METROPOLITAN GOVERNMENT OF NASHVILLE AND DAVIDSON COUNTY

Metropolitan Historic Zoning Commission
Sunnyside in Sevier Park
3000 Granny White Pike
Nashville, Tennessee 37204
Telephone: (615) 862-7970
Fax: (615) 862-7974

STAFF RECOMMENDATION
1214, 1216, and 1220 Rosa L. Parks Boulevard
August 17, 2016

Application: New construction - infill
District: Germantown Historic Preservation Zoning Overlay
Council District: 19
Map and Parcel Numbers: 08209025300, 08213014500, 08213014400
Applicant: George Israel, Architect, Nick Dryden, Architect
Project Lead: Sean Alexander, sean.alexander@nashville.gov

2 NORTH ELEVATION
A3.1 ALONG MONROE AVE

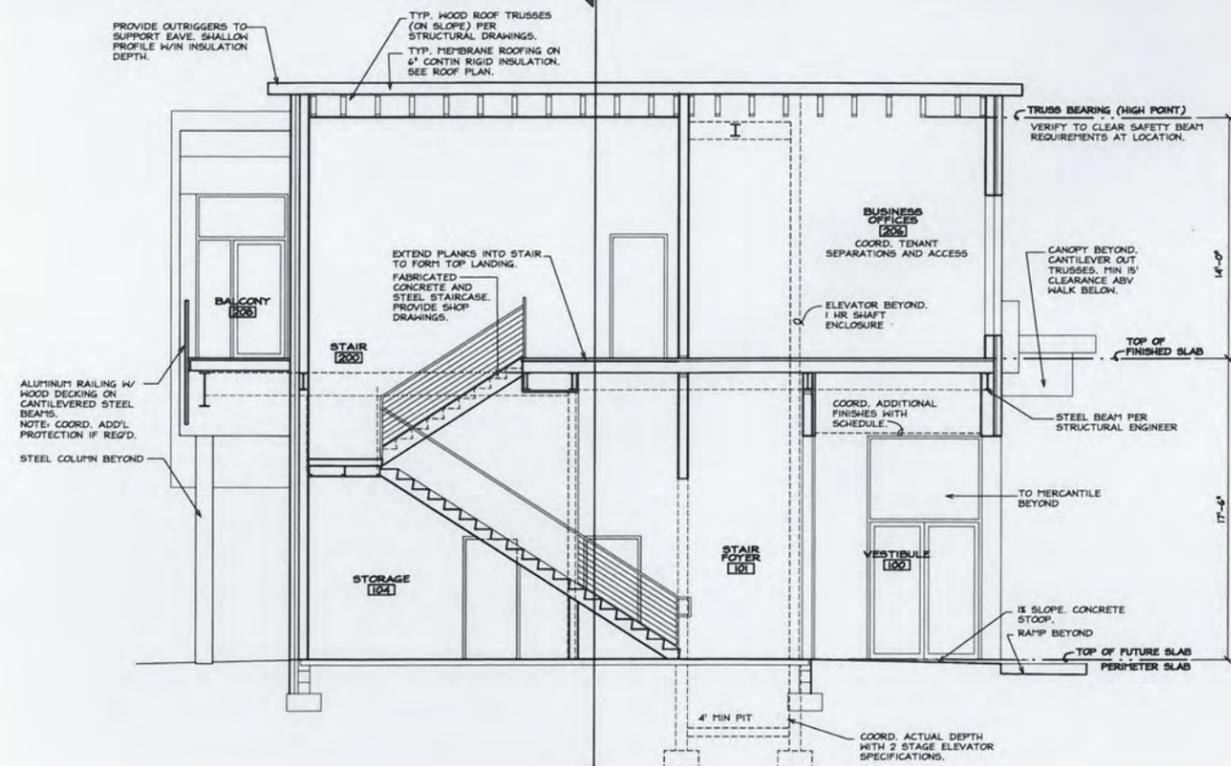
Walls/Exterior Materials: The primary exterior materials on the north and west elevations of this building will include brick, sheet metal trim (sometimes called brake or break metal), and horizontal metal panels. More information is needed about the horizontal aluminum panels to assure that it does not mimic the type of aluminum siding that is inappropriate in Nashville's historic districts.

Secondary materials include: a tubular aluminum screen on the rooftop, a concrete band, smooth steel troweled stucco to mimic limestone, cast concrete and metal canopy. The step-back of the tubular aluminum screen is unknown. Staff finds that the material itself is inappropriate as it is not seen on historic buildings, but may be appropriate depending on its visibility which is dictated by how far it sits back on the rooftop. The concrete band is for signage; however, Staff is unable to review overall signage for the building. A final review of signage may reveal that it does not contribute to the overall plan. Staff recommends that the concreted band only be conditionally approved based on the final approved signage plan.

On the upper story of the building to the right side of the front façade, the plans show a cantilevered metal balcony. Neither front balconies, nor upper level balconies are typical for buildings of this scale and type in the Germantown neighborhood. Staff recommends that this feature be eliminated.

Staff recommends that the front balcony be removed and that the applicant return to the Commission with additional details regarding materials as well as a consideration of simplifying materials, textures and color to meet section 3 for walls and materials.

1. The projecting balcony is removed from the front façade of the northern building;
2. Additional information is provided for the rooftop utility screens;
3. Concrete band not be approved until a final signage plan has been approved;
4. The applicant return to the Commission with additional details regarding materials as well as a consideration of simplifying materials, textures and color to meet section 3 for walls and materials;
5. The terrace “window” openings not be enclosed later, either with windows, plastic or any other type of covering, without a Preservation Permit or a revision of the existing permit; and,
6. The applicant return to the Commission with additional information on signage, lighting, fences, and other appurtenances.

2 SOUTH ELEVATION
A3.2 3/32" = 1'-0"

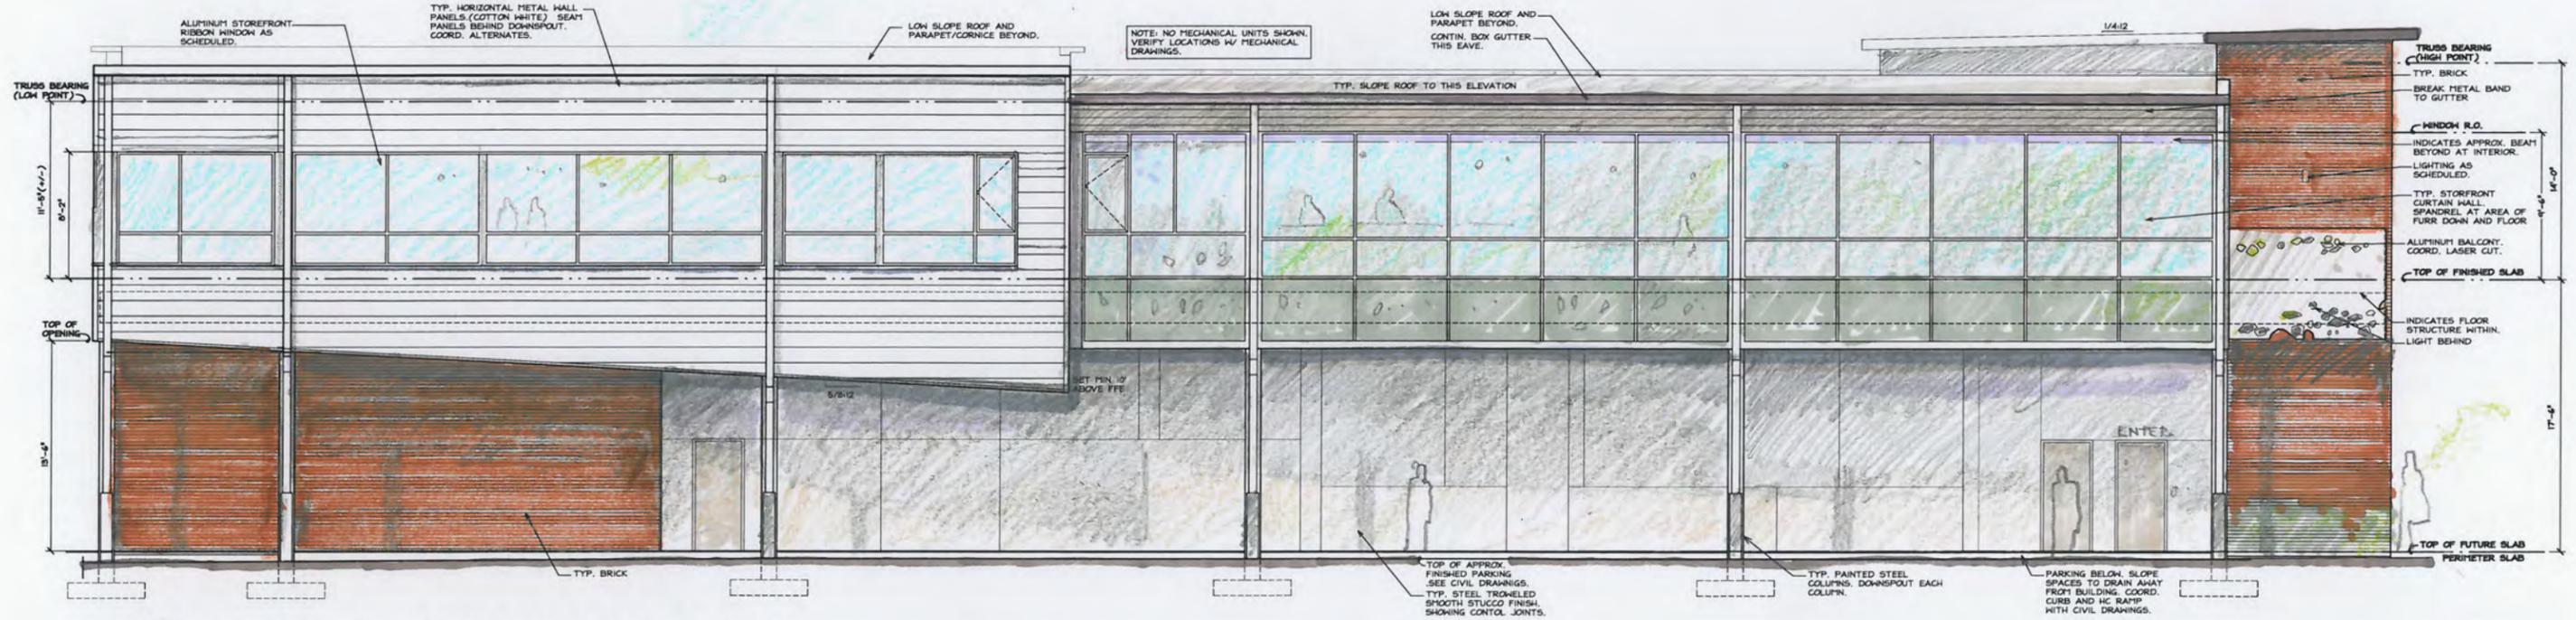
The primary materials on the rear of the building are brick, white metal wall panels, and steel troweled smooth stucco. White metal is inappropriate as industrial metal materials were typically more muted shades of gray, silver and black.

Although the majority of materials appear to be appropriate, more information is needed, Staff has concerns over the number of different materials, colors and textures. Historically buildings typically had one or two primary materials with one or two secondary materials.

2 NORTH ELEVATION
A3.1

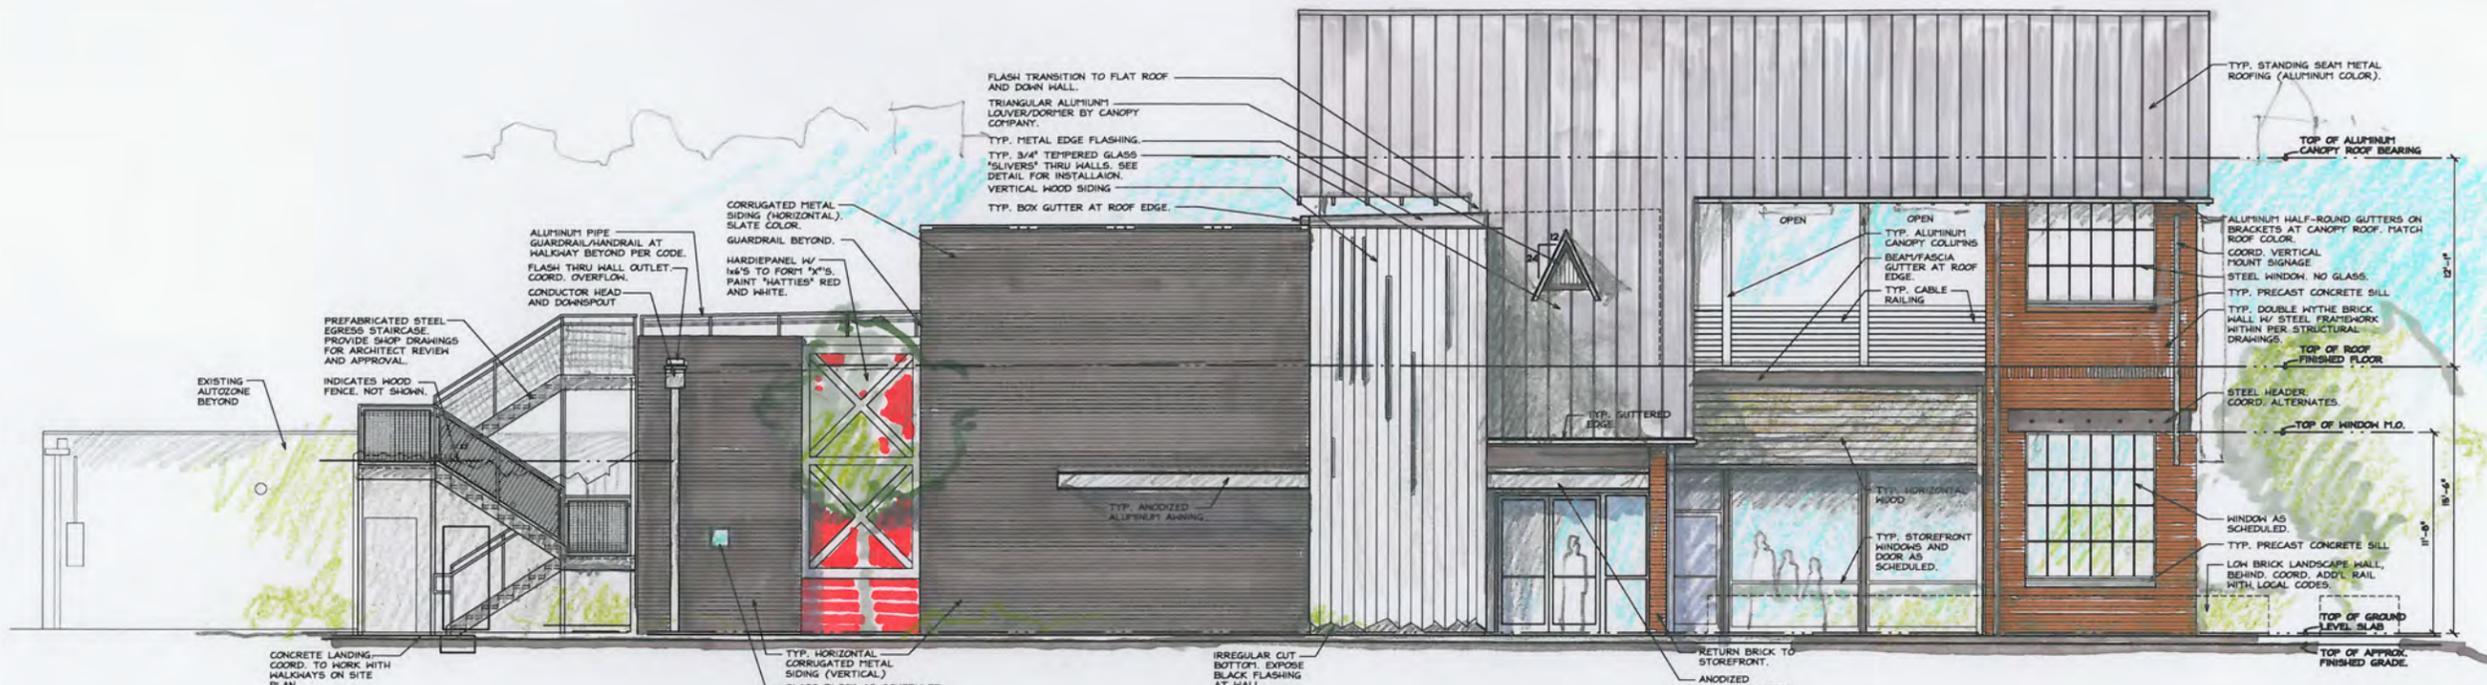
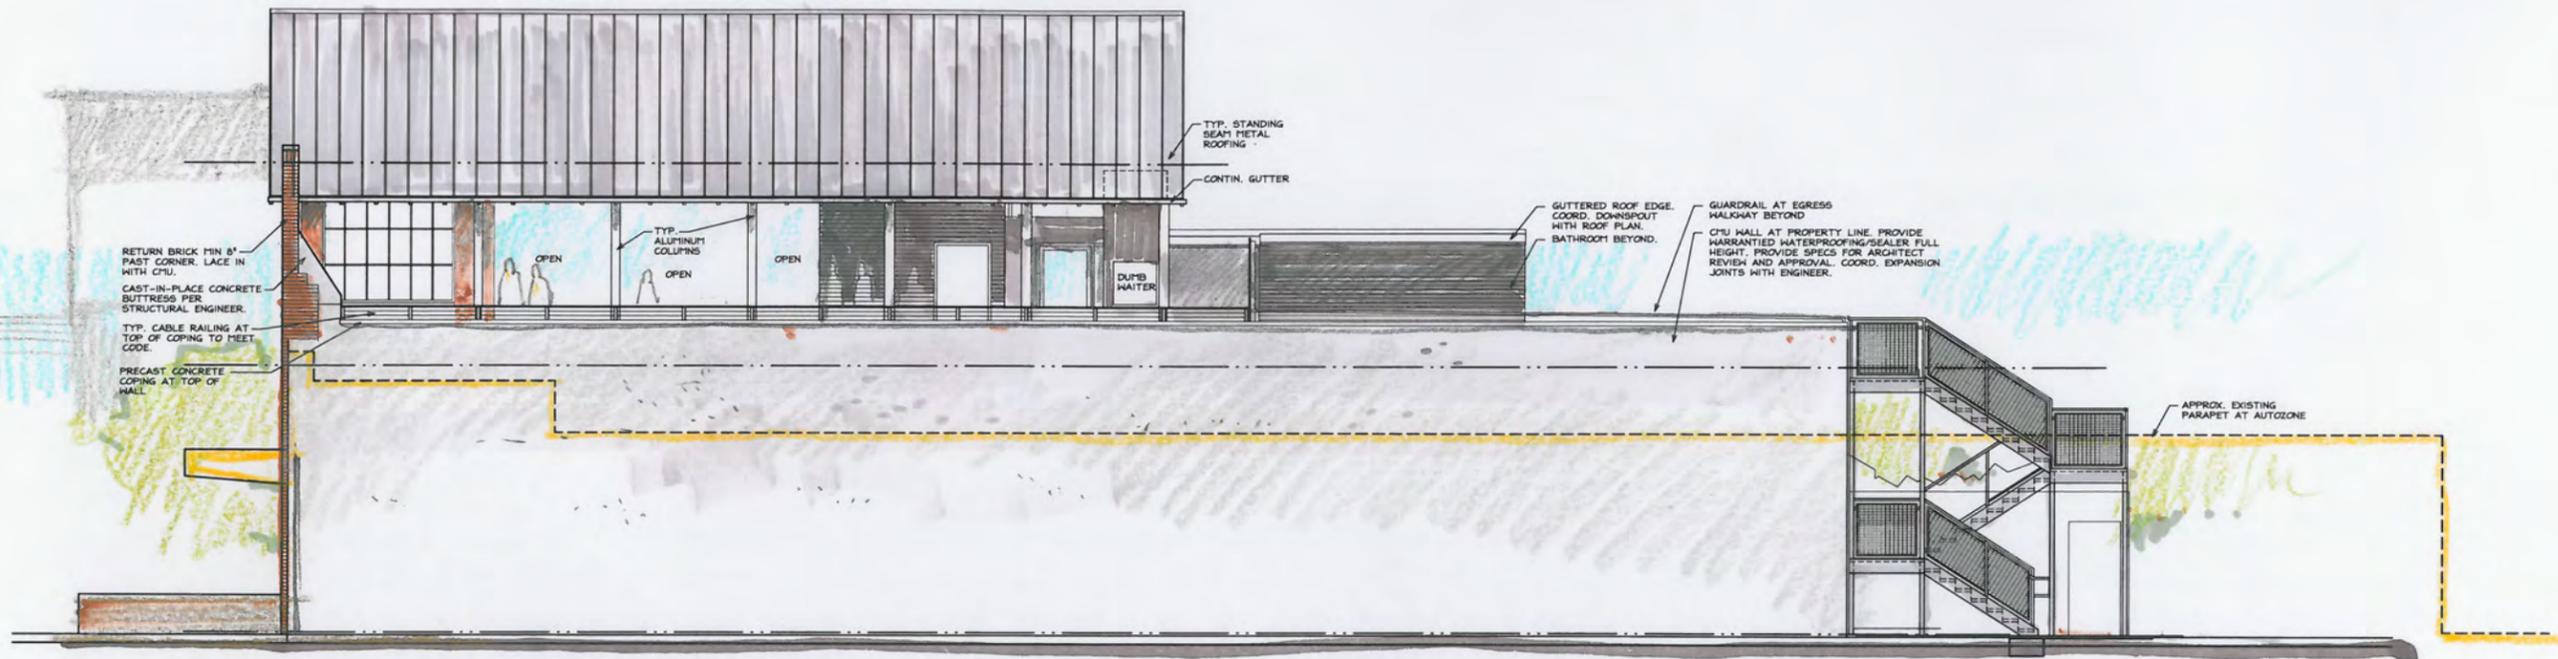
Walls/Exterior Materials: The primary exterior materials on the south building will include brick, vertical wood siding, corrugated metal siding. Secondary materials include hardipanel, horizontal wood siding, and metal louvers. Trim includes limestone or cast stone, steel and metal louvers. The roof is standing seam metal.

Staff finds that these materials are common throughout Germantown, where there is a mixed historical and architectural context that often includes residential, civic, commercial, and industrial buildings juxtaposed in close or adjacent proximity. Although the majority of materials appear to be appropriate, more information is needed, Staff has concerns over the number of different materials, colors and textures. Historically buildings typically had one or two primary materials with one or two secondary materials.

Staff recommends that the applicant return to the Commission with additional details regarding materials as well as a consideration of simplifying materials, textures and color to meet section 3 for walls and materials.

Windows & Doors: The building will have two stories with similar window and door proportions, but only the first story will actually have windows and doors. The

upperstory will be an open-air terrace. Staff recommends that if approved, these openings should not be enclosed later, either with windows, plastic or any other type of covering, without a Preservation Permit or a revision of the existing permit. The first story windows will include aluminum storefront systems and multi-light steel industrial windows. All of the openings on both stories will be vertically oriented and regularly spaced, as is typical of historic commercial buildings.
